METROPOLITAN EDISON COMPANY
JERSEY CENTRAL POWER & LIGHT COMPANY
AND
PENNSYLVANIA ELECTRIC COMPANY
THREE MILE ISLAND NUCLEAR STATION, UNIT 1

Operating License No. DPR-50
Docket No. 50-289
Technical Specification Change Request No. 103

Technical Specification Change Request No. 103

Figure 2.3-1

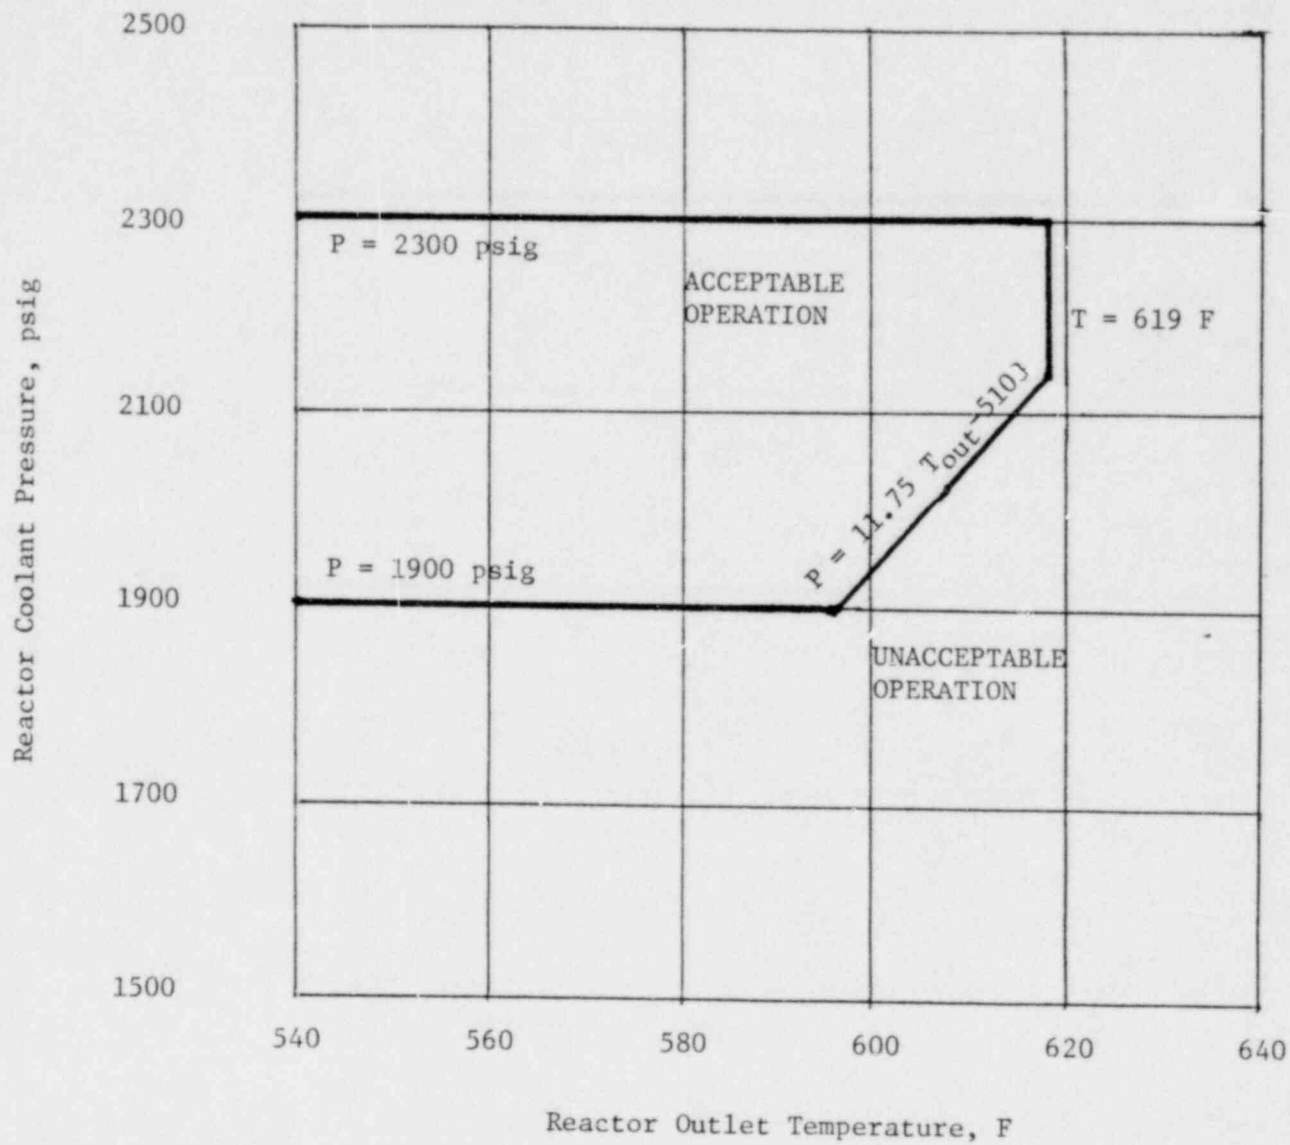
In addition, Technical Specification 2.3.1 (Table 2.3-1, Figure 2.3-1) provides a value of 1800 psig for the RPS Low Reactor Coolant Pressure trip setpoint. The B&W generic ECCS analysis, "ECCS Analysis of B&W's 177-FA Lowered Loop NSS," BAW-10103, Rev. 2, April 1976, referenced a value of 1900 psig for the Low Reactor Coolant System Pressure Trip setpoint based on trip on variable pressure/temperatures at full power. To cover operation at less than full power Technical Specification 2.3.1 increase the Low Reactor Coolant System Pressure Trip Setpoint from 1800 psig to 1900 psig.

In conclusion, with regard to increasing the Low Reactor Coolant Pressure trip (RPS) setpoint from 1800 psig to 1900 psig and increasing the minimum Low Reactor Coolant System (ESAS) channel setpoint from 1500 psig to 1600 psig:

The low pressure (1900 psig) and variable low pressure ($11.75 T_{OUT} - 5103$) trip setpoint were established to maintain the DNB ratio greater than or equal to 1.3 for those design accidents that result in a pressure reduction (3,4). The B&W generic ECCS analysis however, assumed a low pressure trip of 1900 psig and is therefore the basis of low pressure reactor trip. Figure 2.3-1 shows the high pressure, low pressure, and variable low pressure trips.
